Subject: Response to Nuclear Regulatory Commission Request for Additional Information
Re: Request for Relief for the Fourth 10-Year Inservice Inspection Program (TAC No. ME7875)
Cooper Nuclear Station, Docket No. 50-298, DPR-46

**Response to Nuclear Regulatory Commission Request for Additional Information
Re: Request for Relief for the Fourth 10-Year Inservice Inspection Program
(TAC No. ME7875)**

Cooper Nuclear Station, Docket No. 50-298, DPR-46

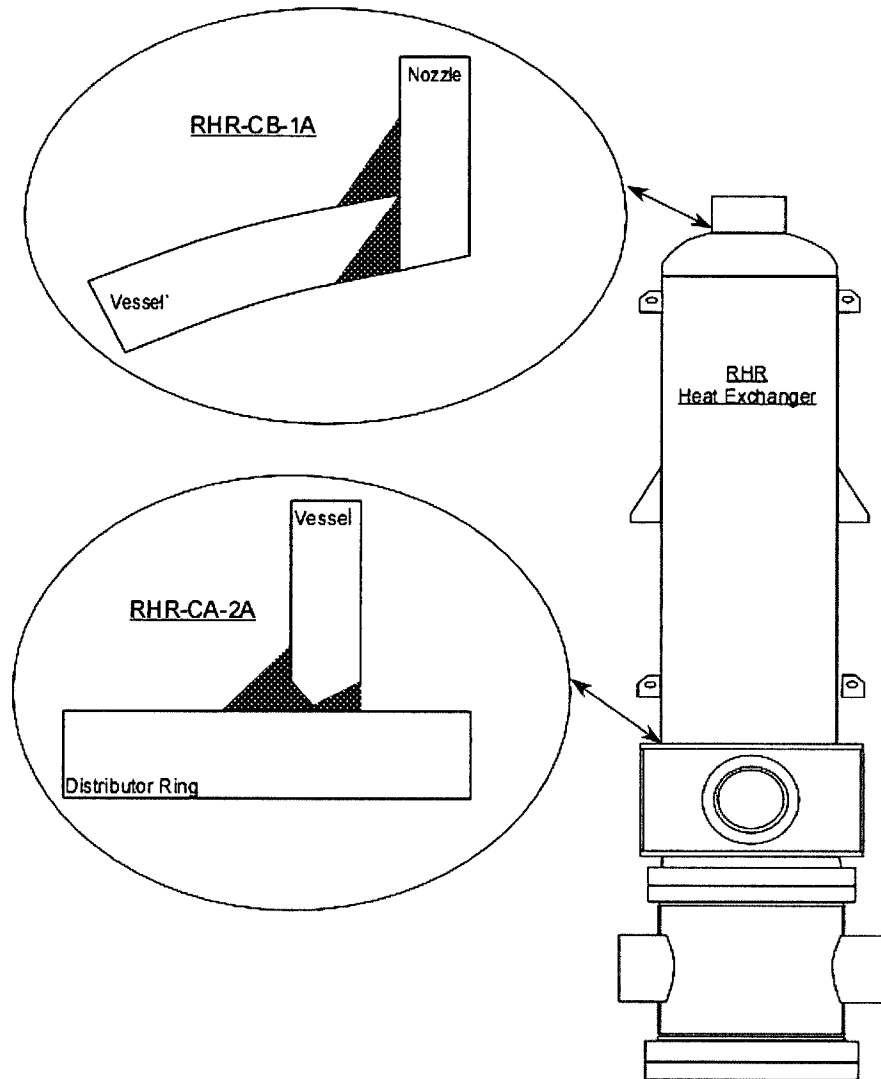
Please provide a diagram of the residual heat removal vessel on which the examinations were performed indicating on the diagram where the welds of interest are located.

Response #4

See following Figure:
